Form C-103
May 27, 2004

WELL API NO. 30-025-31551
5. Indicate Type of Lease STATE <input checked="" type="checkbox"/> FEE <input checked="" type="checkbox"/>
6. State Oil & Gas Lease No. B2359
7. Lease Name or Unit Agreement Name Lovington San Andres Unit
8. Well Number: 85
9. OGRID Number
10. Pool name or Wildcat Lovington Grayburg San Andes

SUNDRY NOTICES AND REPORTS ON WELLS (DO NOT USE THIS FORM FOR PROPOSALS TO DRILL OR TO DEEPEN OR PLUG BACK TO A DIFFERENT RESERVOIR. USE "APPLICATION FOR PERMIT" (FORM C-101) FOR SUCH PROPOSALS.)

LSAU #85
API No. 30-025-31551

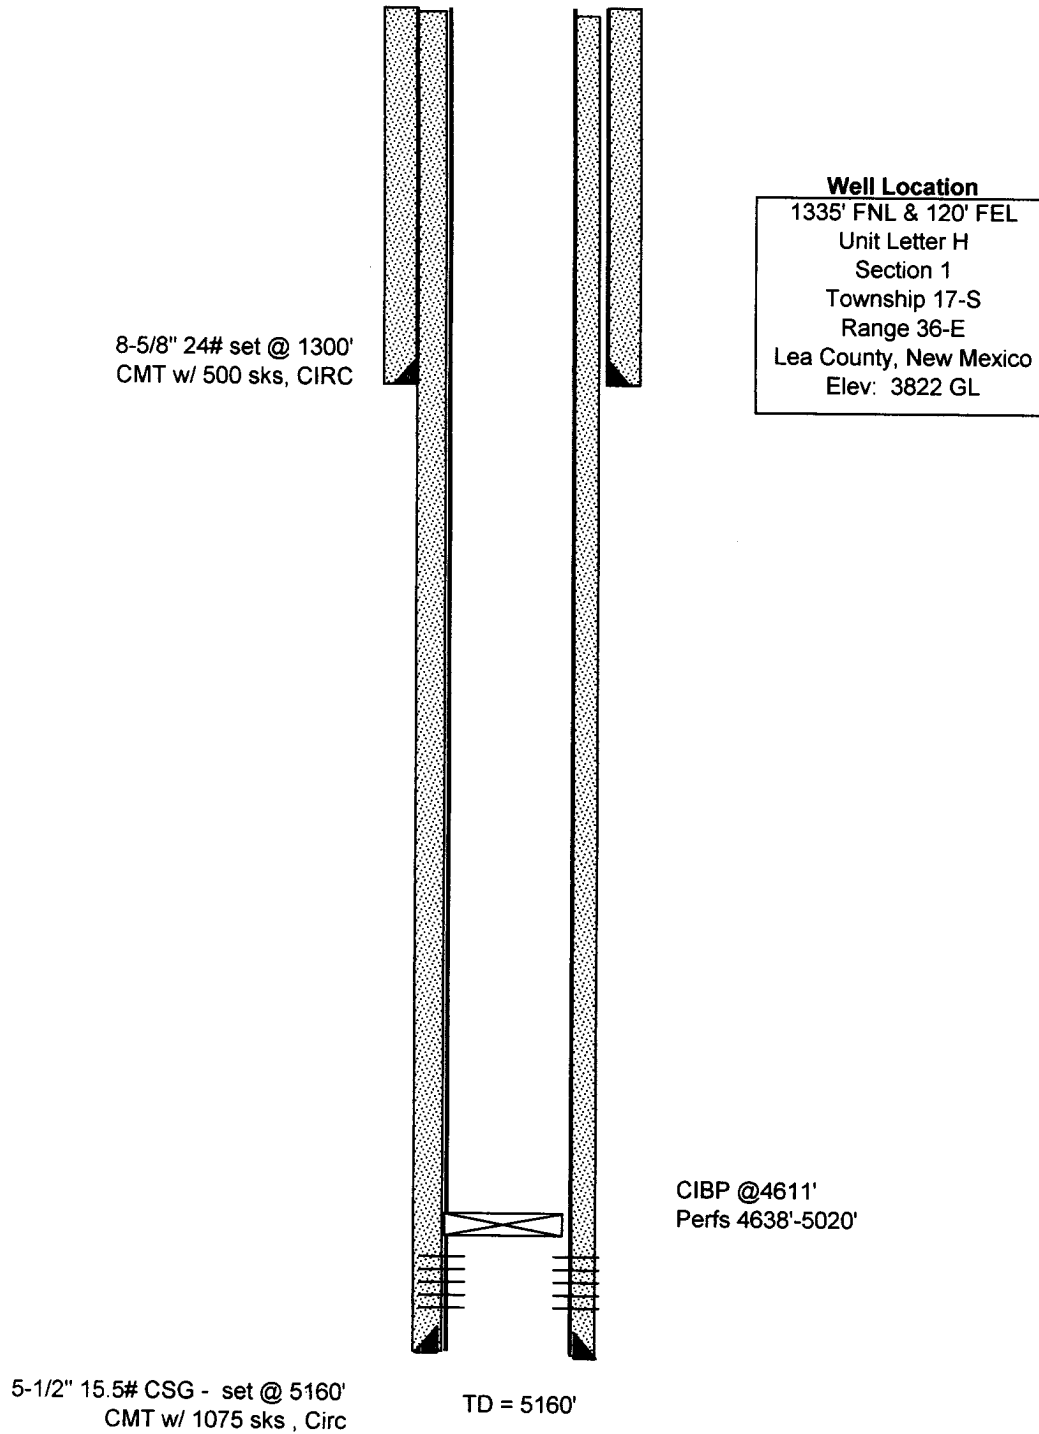
→ SPOT 25 SX PLUG F/ 400'-300' (FRESH WATER PLUG)
